# THE ELIZABETH LOFTS BY: THE BOULEVARD COMPANY

## ELIZABETH LOFTS

SUBJECT: Administrative Approval for Petition No. 96-36  
Elizabeth Lofts - The Boulevard Company  
Tax Parcel Nos. 127-094-07 through 11

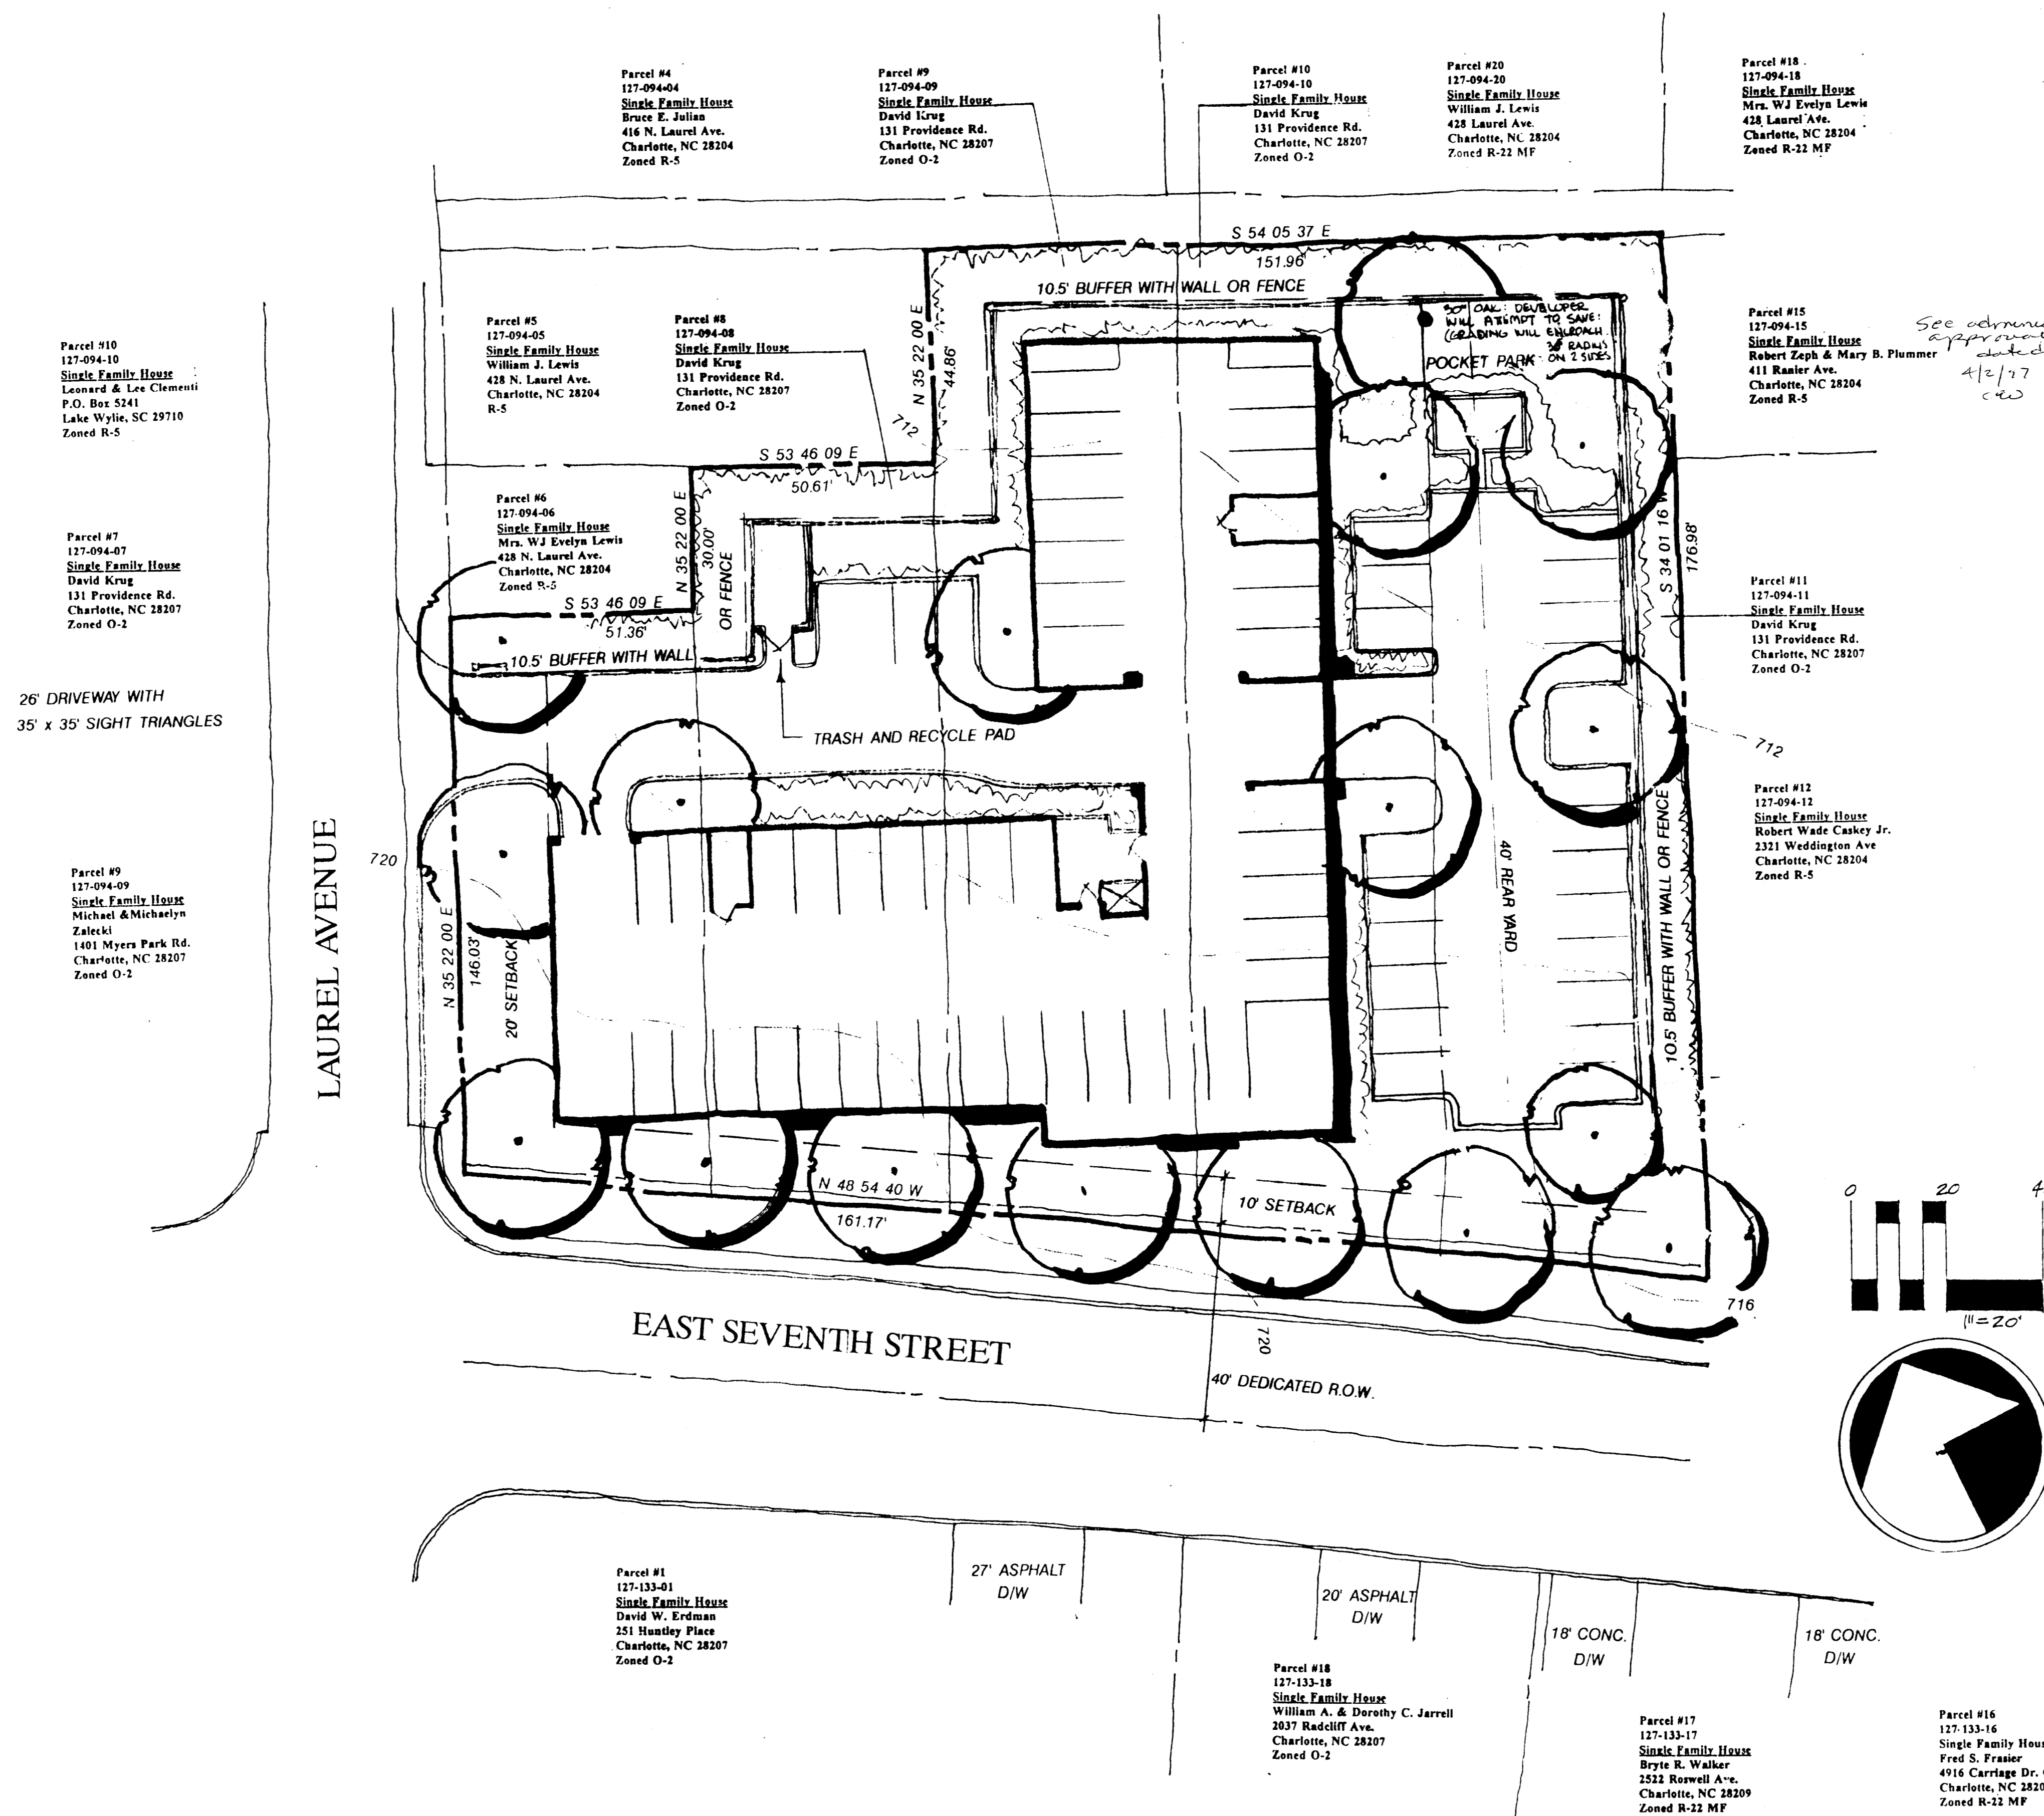
Attached is a revised site plan for the above-mentioned rezoning petition. The revised site plan reflects two changes: the trash compactor/dumpster has been relocated towards the project entrance and five parking spaces have been omitted. These changes are being made in an attempt to save an existing thirty inch oak and to provide more useable open space for the project. The dumpster will be effectively screened from adjacent properties in the new location. Also the required number of parking spaces is 65 so the project will still comply with the minimum standards of the ordinance. We feel these changes are minor so we are administratively approving this revised plan. Please use this revised site plan when evaluating requests for building permits and certificates of occupancy.
